Access Compliance Report Public Rights-of-Way (Curb Ramps)

Intersection ID: 22011	Main Street: SOUTH_BV	Cross Street: HILL_RD	Location: SE
ADA ID: BCB645694527	Ramp Type: Para	Initial Pass/Fail: Fail	Overall Compliance: No Severity Score: 13.75

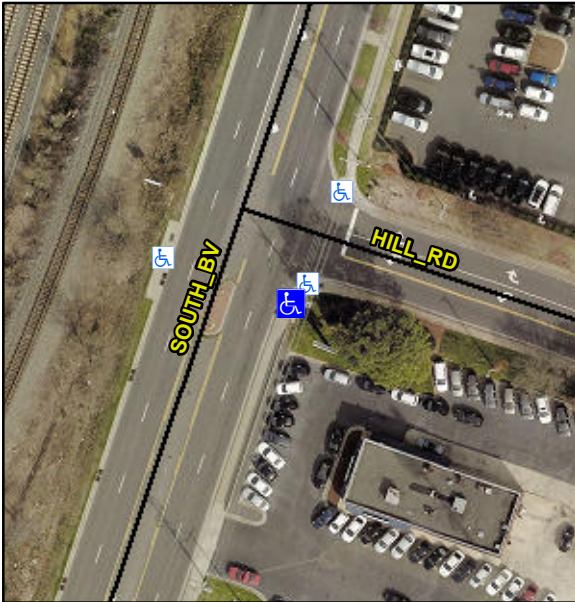
Compliance	Description	Data	Compliance	Description	Data
N/A	Ramp Length LT (in)	58.0	N/A	Ramp Length RT (in)	58.0
Yes	Ramp Width LT (in)	60.0	Yes	Ramp Width RT (in)	71.0
No	Ramp Slope LT (%)	9.3	No	Ramp Slope RT (%)	9.0
No	Ramp XSlope LT (%)	2.9	No	Ramp XSlope RT (%)	2.1
N/A	Landing Length (in)	N/A	N/A	DWS Provided?	N/A
N/A	Landing Width (in)	N/A	N/A	DWS Contrast?	N/A
N/A	Landing Slope (%)	N/A	N/A	DWS Length (in)	N/A
N/A	Landing X Slope (%)	N/A	N/A	DWS Full Width?	N/A
N/A	Landing Curb? (Y/N)	N/A	N/A	DWS Offset (in)	N/A
N/A	Shared Landing?	N/A			
N/A	Gutter Ponding?	N/A	N/A	Gutter Slope (%)	N/A
N/A	Gutter Lip Ht (in)	N/A	N/A	Gutter X Slope (%)	N/A
N/A	Painted X Walk1?	No	N/A	Painted X Walk2?	N/A
	X Walk 1 Direction	To NW		X Walk 2 Direction	N/A
N/A	X Walk 1 Width (in)	N/A	N/A	X Walk 2 Width (in)	N/A
	X Walk 1 Slope (%)	3.0		X Walk 2 Slope (%)	N/A
	X Walk 1 X Slope (%)	1.2		X Walk 2 X Slope (%)	N/A
N/A	Ramp inside XWalk1?	N/A	N/A	Ramp inside XWalk2?	N/A

Road Slope (%)	N/A	N/A	Clear Space?	N/A
	Road X Slope (%)	N/A	N/A	Clear Space to XWalk (in)	N/A
N/A	Any Obstructions?	N/A	N/A	Storm Grate/Utility Hazard?	N/A
	Obstruction Type			Storm Grate/Utility Type	
	Total Cost:	\$ 1600.00	N/A		N/A
			Yes	Surface Condition? (G/P)	Good
			N/A	Curb Slope (%)	7.0

Possible Solutions:

Remove & Replace Entire Ramp.
